APPLICATION NO.	FILING DATE	FIRST NAMED INVENTOR	ATTORNEY DOCKET NO.	CONFIRMATION NO.
10/721,474	11/25/2003	Chimsong Sul	10030034-1	6056
7590		03/02/2007	EXAMINER	
AGILENT TECHNOLOGIES, INC.			TRIMMINGS, JOHN P	
Intellectual Property Administration			ART UNIT	PAPER NUMBER
Legal Department, DL 429			2138	
P.O. Box 7599				
Loveland, CO 80537-0599

**Advisory Action
Before the Filing of an Appeal Brief**

Appln No. 10/721,474
Response to OA of 9-19-2006
REPLACEMENT DRAWING

Fig. 4

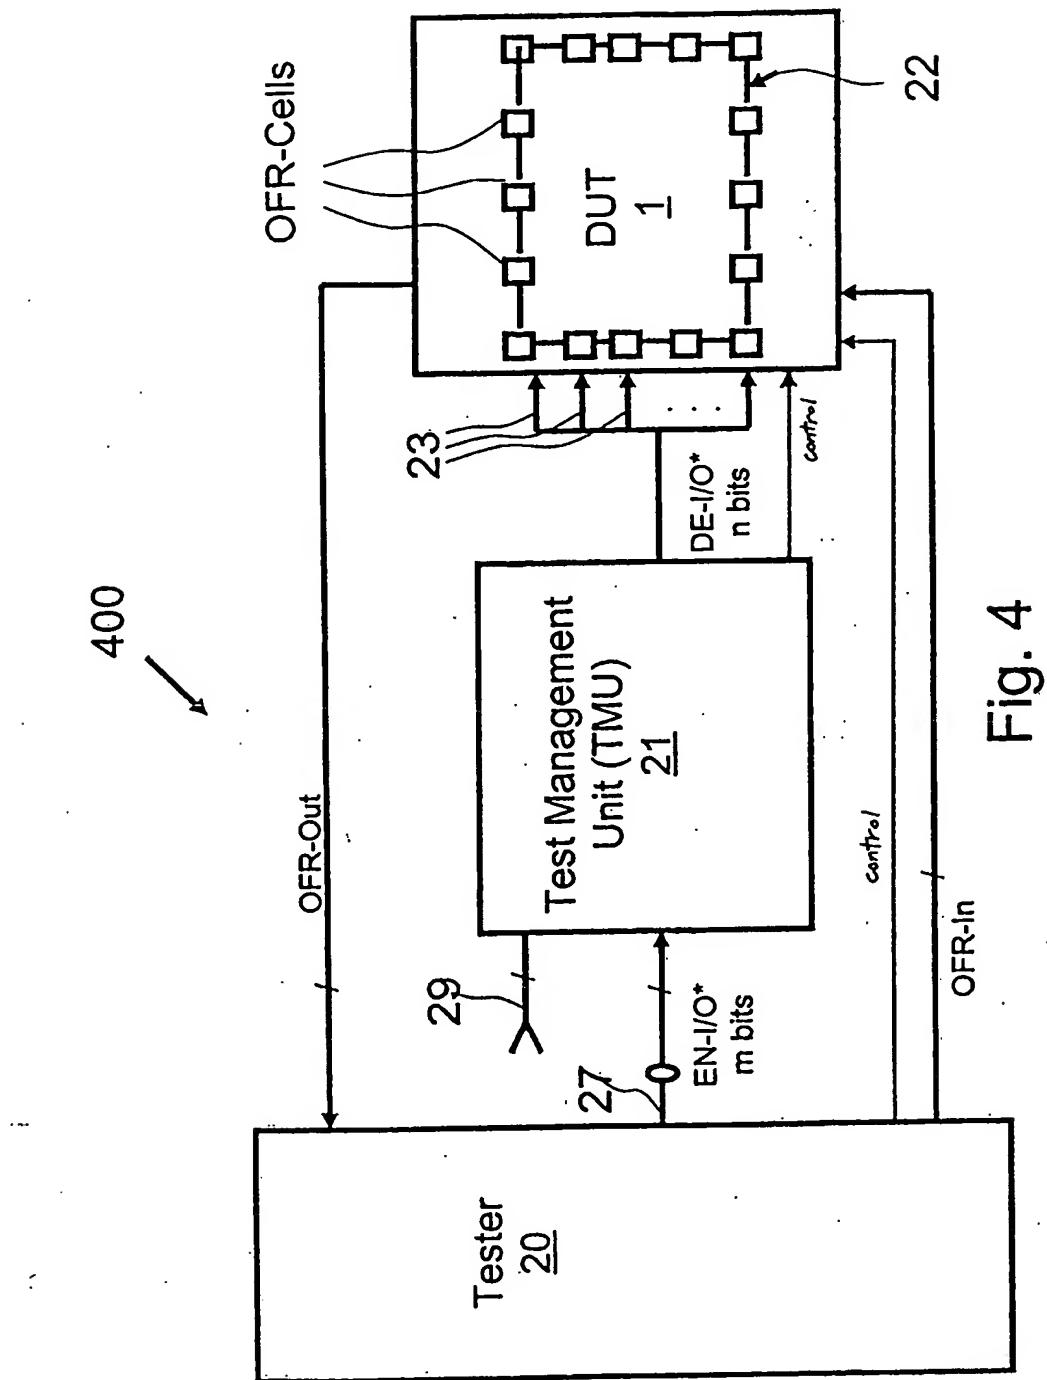
The examiner however approves the entry of the applicant's amended FIG. 4 into the record.

Entry is approved. 2/22/07 PL
